From: John Joiner <jjoiner@whks.com>
Sent: Tuesday, July 7, 2026 1:05 PM
To: Jordan Cook; Erin Mousel; Justin Schiermeister
Cc: Joe Mousel; Mike Sauer; Derek Thomas; Sam Sytsma; Noah Collins; Scott Kruse; Lucas Battani
Subject: RE: Trunkline Rehabilitation - Change Order No.2
Attachments: Trunkline CO 2 - UPDATED.pdf; Trunkline Rehab - CO 2 Plan Sheet - UPDATED.pdf; Orchard Proposal for CO#2 - UPDATED.pdf

2026 Sanitary Sewer MH Rehab (Nevada Trunkline Sewer)

Proposal.02 Manhole Revisions

Change Order No.2

Change Order No.2 - Items of Work

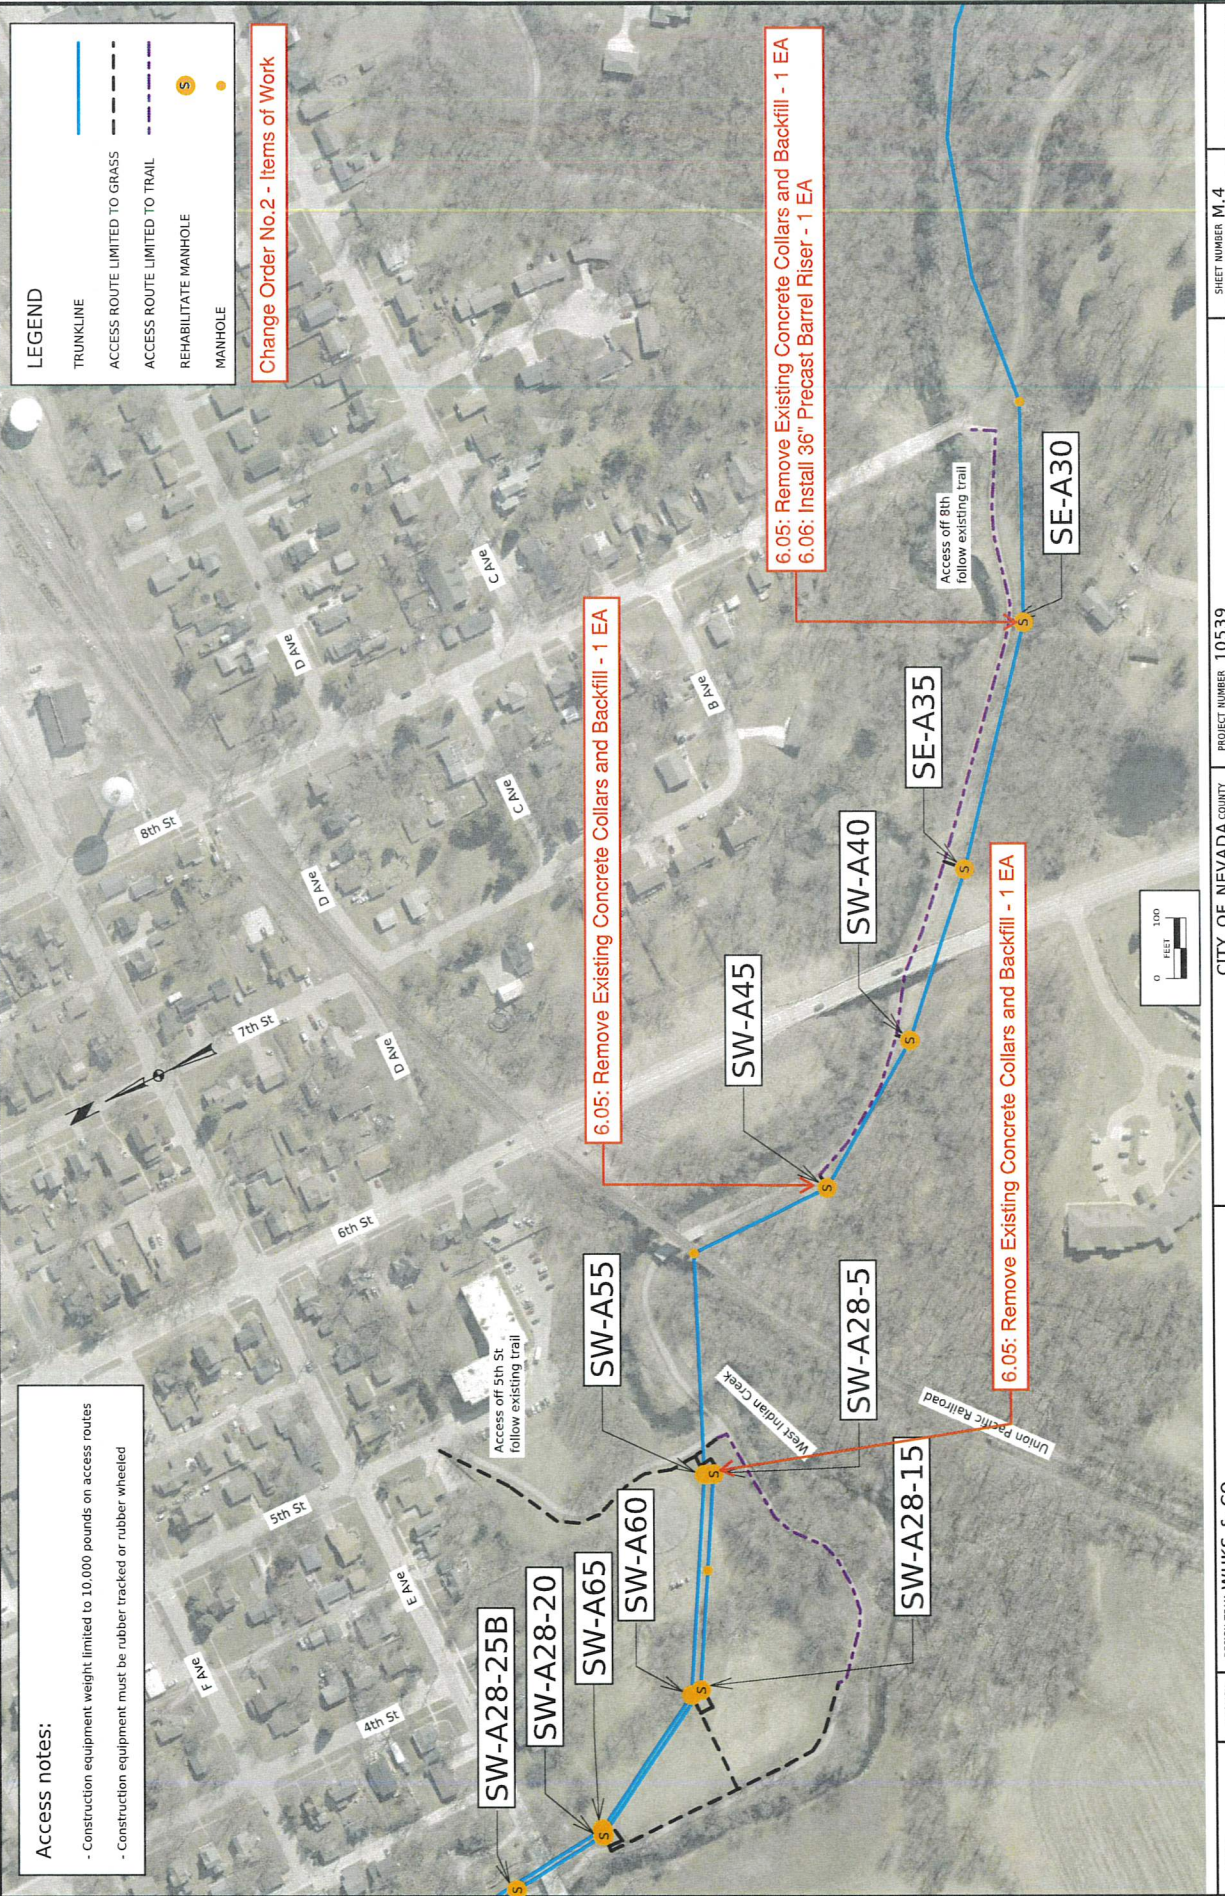
During the flood on July 4, Manhole SW-A28-5 (see attached plan) suffered damage. Repairs to the manhole will be made as described below with removal of the large concrete collar and backfill to facilitate the standard casting and chimney replacement. Change Order No. 2 (attached) includes repairs to this storm damaged manhole (SW-A28-5) along with the work described below for manholes SE-A30 and SW-A45.

During construction, it was discovered that most of the manholes have a significant amount of concrete that was poured around the chimney and casting. These concrete collars are around 6' in diameter and up to 3' in depth. This is highly unusual practice, especially to the extent being found, and was unexpected by the contractor. An alternative rehabilitation method that leaves the majority of these concrete collars in-place, was agreed upon and approved under Change Order No.1. However, two manholes along the West Indian Creek Path (SE-A30 and SW-A45), were found to have significant infiltration around the cone and risers, thus the large concrete collars need to be removed and backfilled in these locations (new Item 6.05) to facilitate the standard casting and chimney replacement to be completed. Additionally, Manhole SE-A30 was discovered to be buried/submerged and needs to be raised using a 36" barrel riser section (new Item 6.06).

The additional work required to remove the existing 30" collars on SE-A30 and SW-A45, install an additional 36" precast riser section on SE-A30, and replace the casting / chimney seals on SE-A30 and SW-A45, then replace the flat tops instead of doing casting repairs on B5-30 and SE-B5-25 as directed by the City of Nevada.

ITEM	DESCRIPTION	UNIT	PRICE	QUANTITY	TOTAL
6.05	Remove Existing Concrete Collars and Backfill	EA	\$2,110.00	3.00	\$6,330.00
6.06	Install 36" Precast Barrel Riser	EA	\$5,740.00	1.00	\$5,740.00
<i>It is mutually agreed that the contract price is increased/decreased by:</i>				Total:	\$12,070.00

Description	Quantity	Unit	Unit Price	Amount
6.1) Casting/Chimney Replacement PCC Manholes (SE-A30 and SW-A45)	2 3	EA	\$2,900.00	\$5,800.00 \$8,700.00
6.2) Flat Top Casting Repair (SE-B5-30 and SE-B5-25)	(2)	EA	\$1,450.00	(\$2,900.00)
6.3) Replace Flat Top (SE-B5-30 and SE-B5-25)	2	EA	\$5,800.00	\$11,600.00
6.4) Revised Manhole Repair (SE-A30 and SW-A45)	(2) (3)	EA	\$2,800.00	(\$5,600.00) (\$8,400.00)
6.5) Remove Existing 30" Concrete Collars and Backfill (SE-A30 and SW-A45)	2 3	EA	\$2,110.00	\$4,220.00 \$6,330.00
6.6) Install Additional 36" Precast Riser Section (SE-A30)	1	EA	\$5,740.00	\$5,740.00
				\$12,070.00
